CI 136.8.11 Link Training Issue

July 2020

Kent Lusted, Intel

Figure 136-7—PMD control state diagram

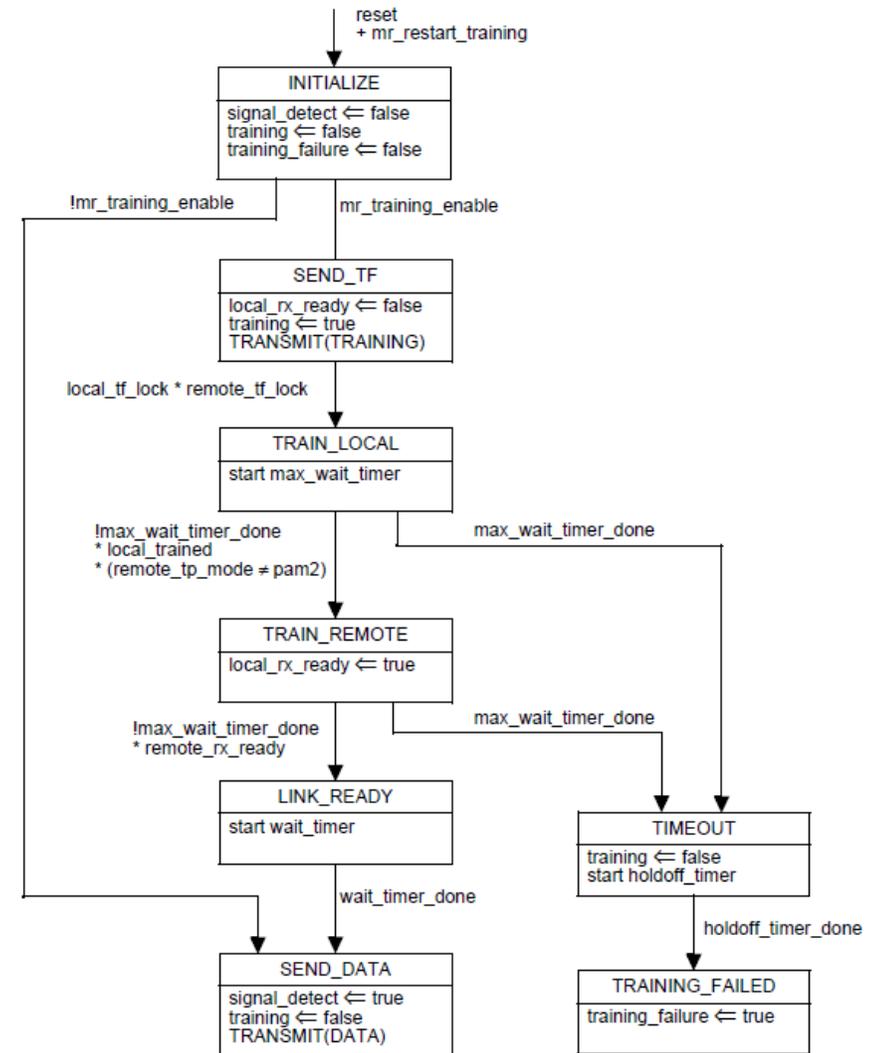
- The currently defined state machine in Clause 136.8.11 (Figure 136-7) does not autonomously recover from a partner restarting during link training in this “force PHY speed” case
 - Note: observed when the Clause 73 Auto-Negotiation state machine is not used.
- Unless a high-level management agent (i.e. SW or FW) detects the condition, the result could be either a persistent link down (i.e. link never comes up) or a link oscillation (up/down/up/down/etc).

- Reset of Device #1 was not captured by Device #2
- The signals local_tf_lock and remote_tf_lock are only checked moving from the SEND_TF state to the TRAIN_LOCAL state.
 - Note: CI 73 AN state machine (if it was used in this case) would expire link_fail_inhibit_timer and breakout out of the condition

- Do nothing
- Increase the duration of the holdoff_timer to exceed that of the max_wait_timer (≥ 12 seconds)
- Add monitoring of the local and received frame lock status (with TBD hysteresis) after the initial frame lock is achieved
- Implement an abort signaling mechanism
